AGENDA SECTION: PUBLIC HEARINGS	ORIGINATING DEPT: PLANNING	ITEM NO. E 13
ITEM DESCRIPTION: Preliminary Plat #02-66 to be known as Manorwood Lakes Seventh, by Western Walls, Inc. The plat contains 27.10 acres to be subdivided into 50 single family home lots and 3 Outlots. The property is located adjacent on the east to Manorwood Lakes 5 th and 6 th Subdivisions at the present termini of Lake Meadow Drive NW and Lake Vista Drive NW.		PREPARED BY: Theresa Fogarty, Planner

RE: Preliminary Plat #02-66 to be known as Manorwood Lakes Seventh, by Western Walls, Inc. The plat contains 27.10 acres to be subdivided into 50 single-family home lots and 3 outlots. The property is located adjacent on the east to Manorwood Lakes 5th and 6th Subdivisions at the present termini of Lake Meadow Drive NW and Lake Vista Drive NW.

PRELIMINARY PLAT

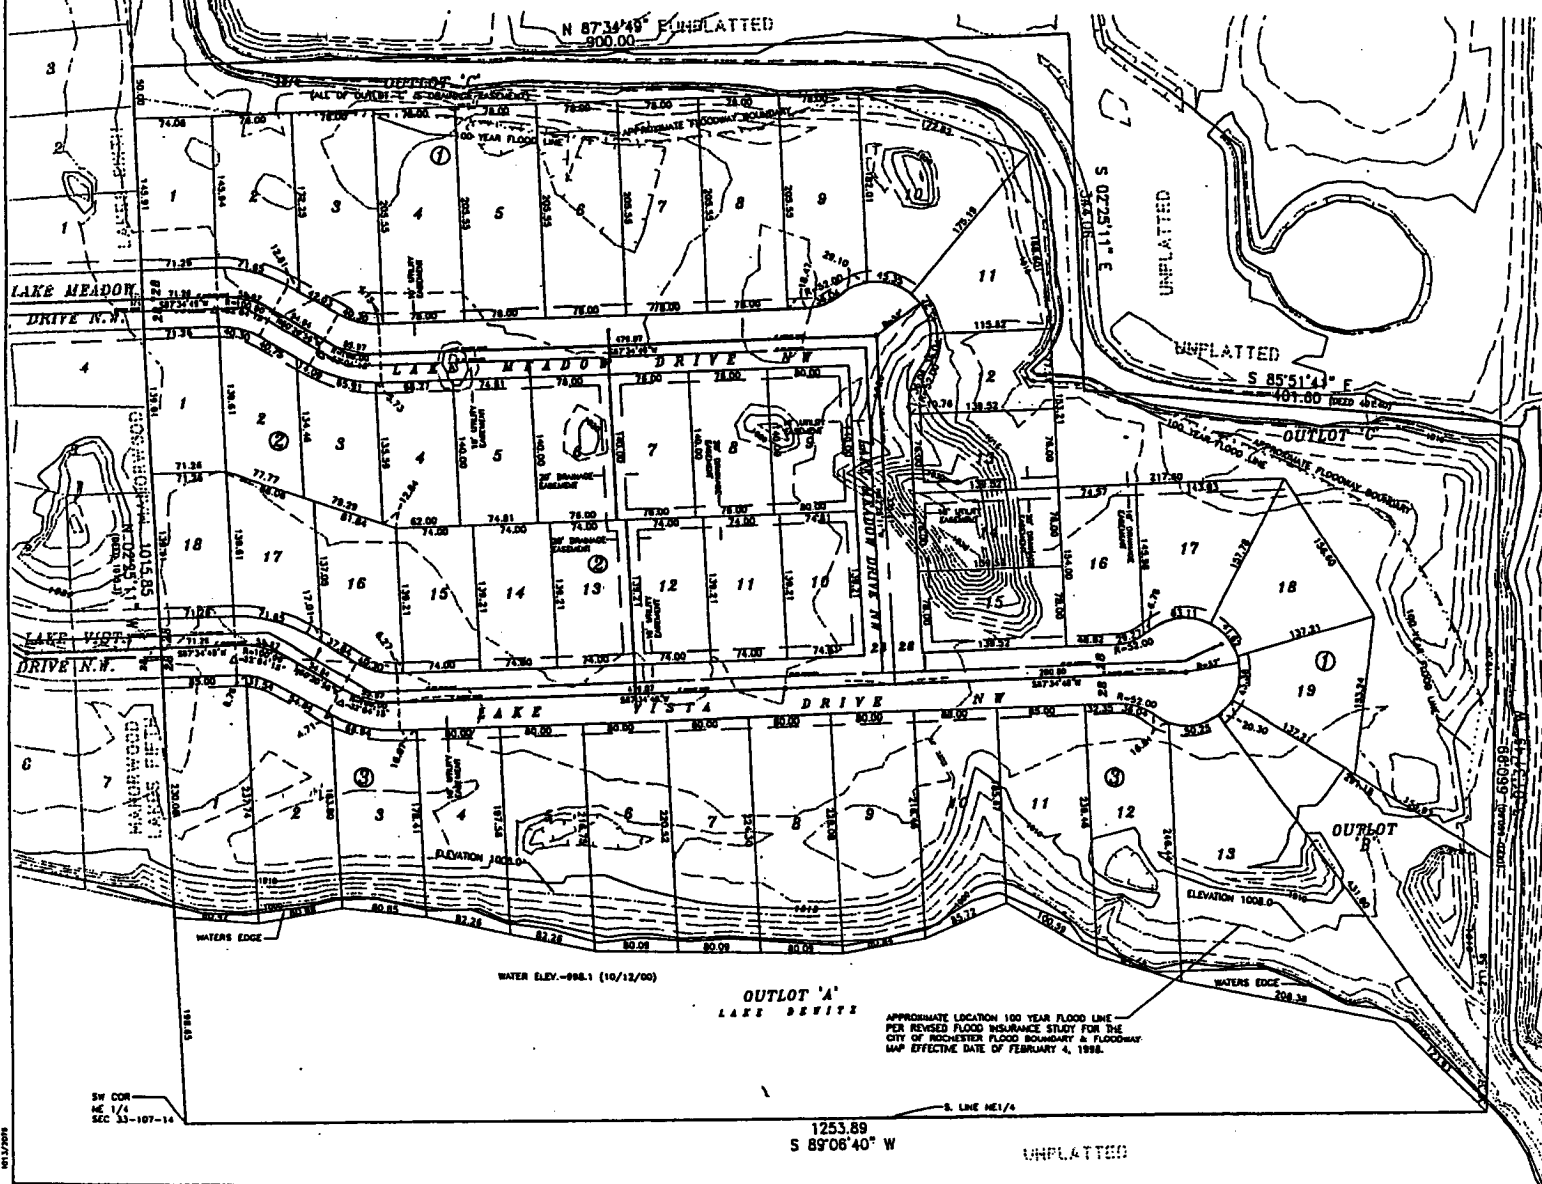
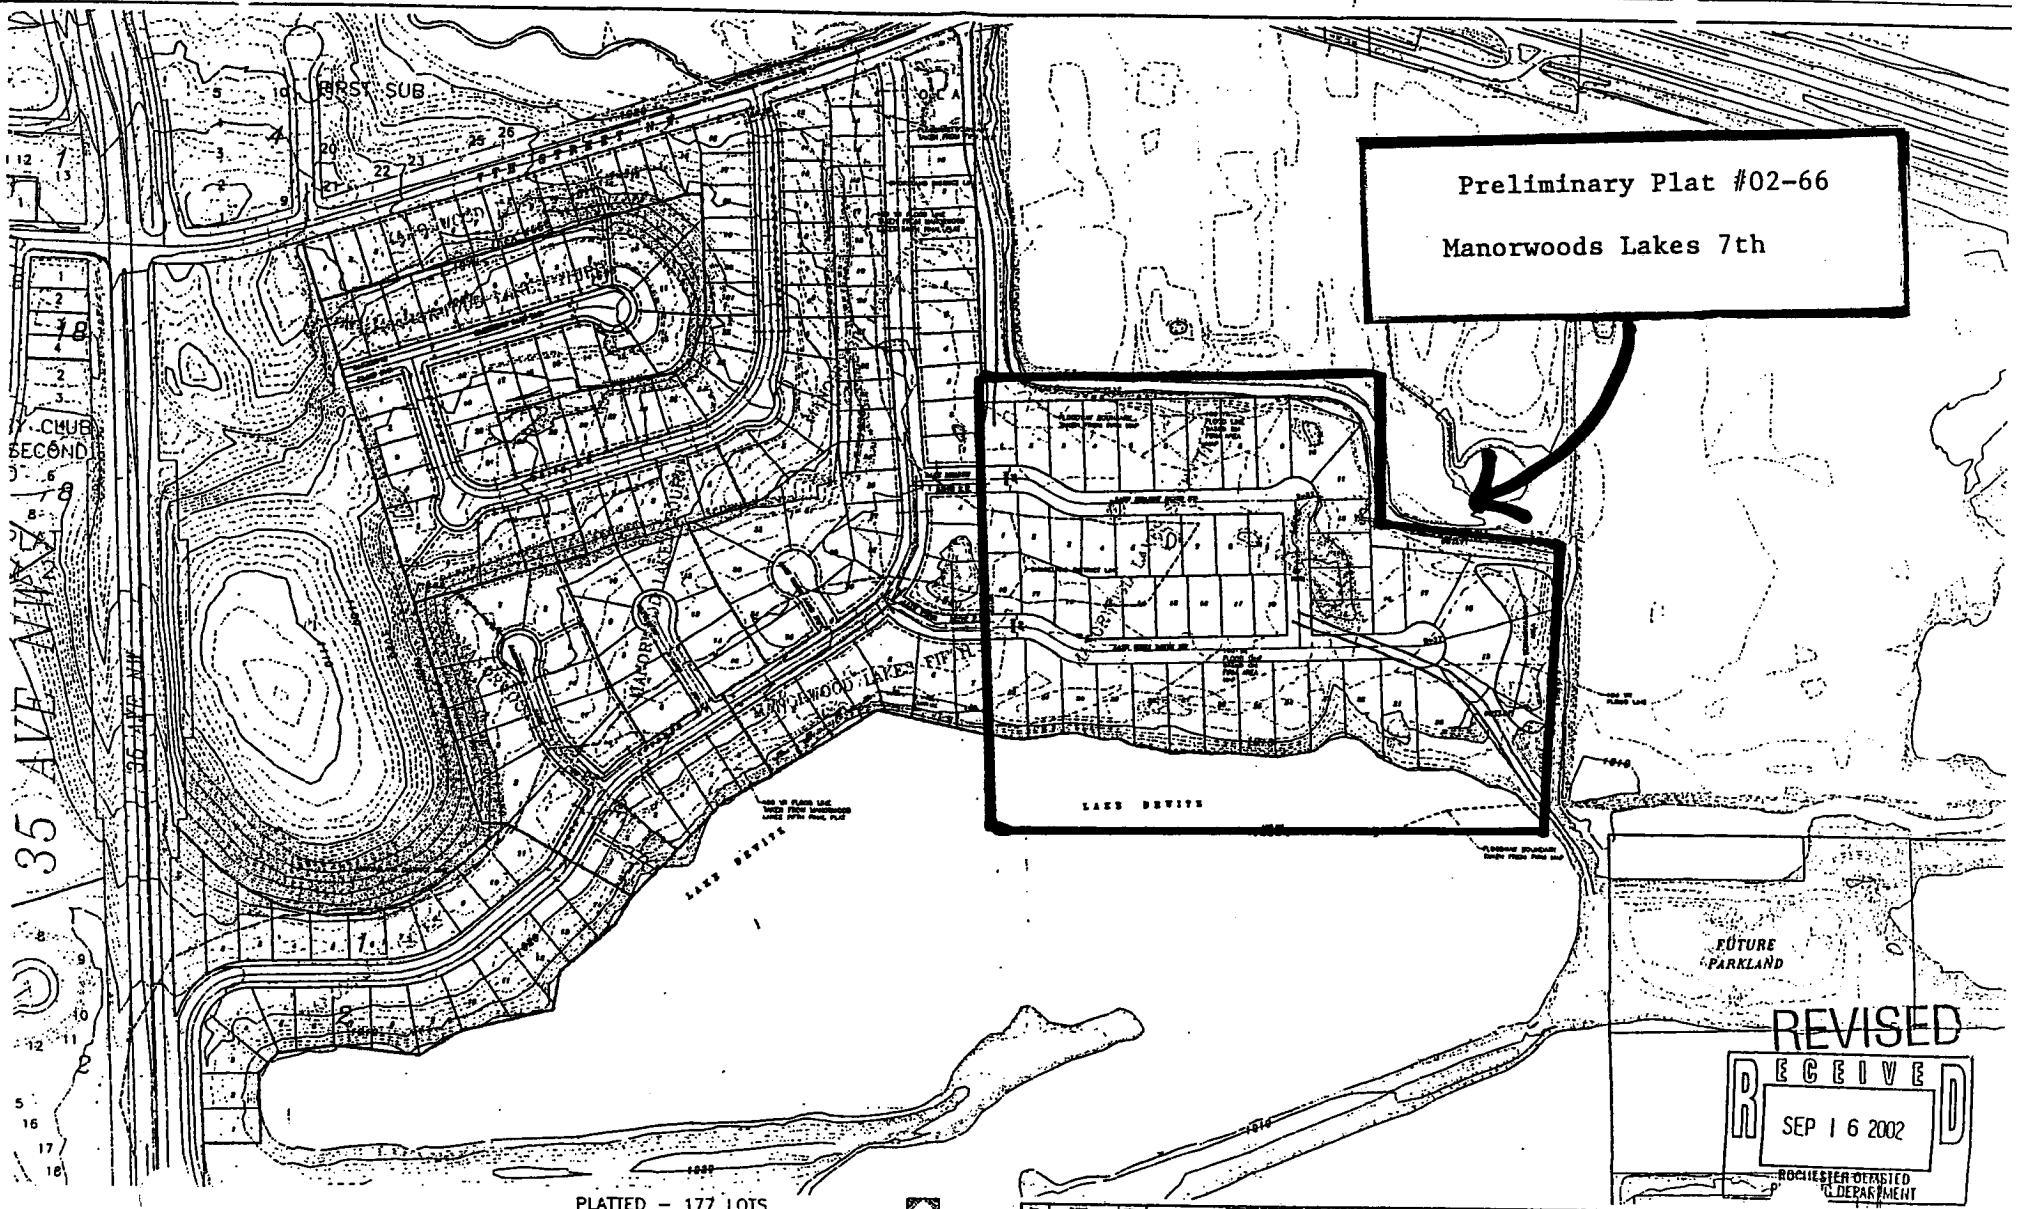
A 20' minimum utility easement is required between Lots 7 & 8, Block 1 for a planned 8" water main loop by Rochester Public Utilities in the future. An 8" water main must be stubbed out of the street area at this time to accommodate this future loop.

The hydrant spacing along Lake Meadow Drive NW is inadequate and will require an additional fire hydrant in front of Lots 8 or 9.

1. ***The Plat shall be revised, prior to the Council meeting to include::***
 - a. ***Provide a minimum 30' wide access along Outlot 'B' from Lake Vista Drive NW.***

- b. ***Provide a minimum 20' utility easement between Lots 7 & 8, Block 1, for a future planned 8" water main loop. An 8" water main must be stubbed out of the street area at this time to accommodate the future loop.***

- c. ***At the time of final plat submittal, show a drainage easement over the entire area within the floodway, and the 100 year flood plain.***
 - d. ***Provide an access to the outlot over the creek corridor with sufficient width to permit adequate access to accommodate waterway maintenance activities and an additional access to the Outlot from the public road.***

3. ***An additional fire hydrant shall be provided along the frontages of Lots 8 or 9 on Lake Meadow Drive NW.***
4. ***The sedimentation basin indicated on the GDP shall not be located on Outlot B.***

GENERAL DEVELOPMENT PLAN
MANORWOOD LAKES

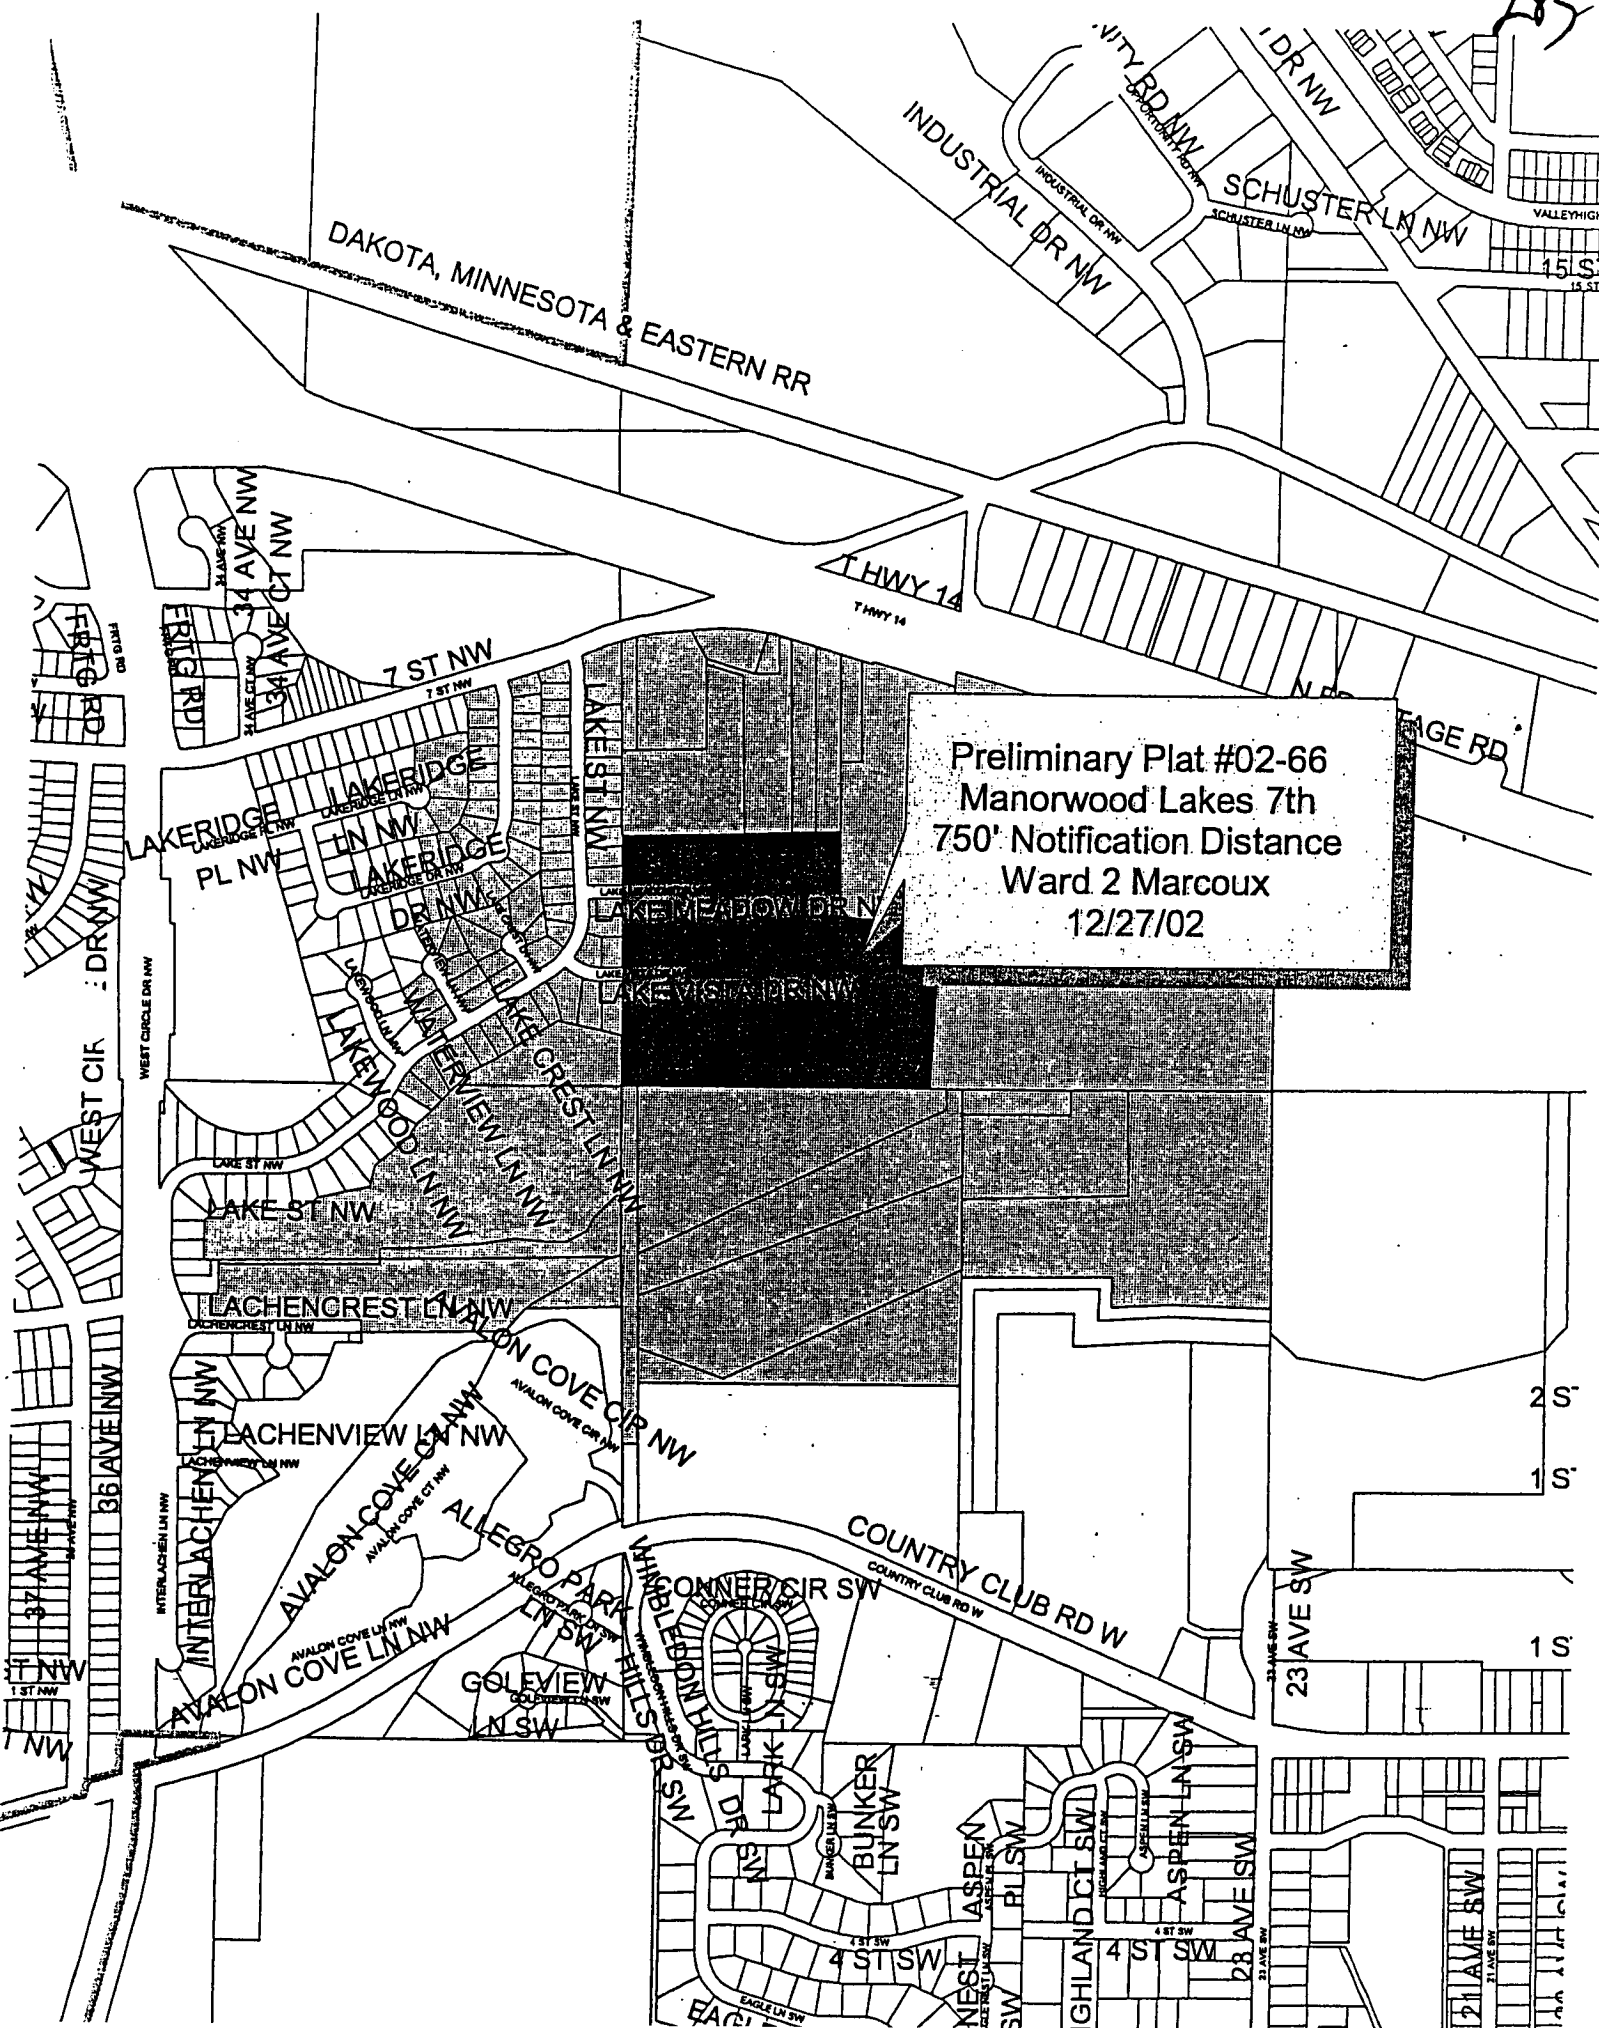
The plat does not meet the GDP approval condition requiring "the outlot over the creek corridor shall be widened to permit adequate access to accommodate waterway maintenance activities and an additional access to the Outlot from the public road shall be provided".

The sedimentation basin indicated on the GDP should not be located on Outlot B.
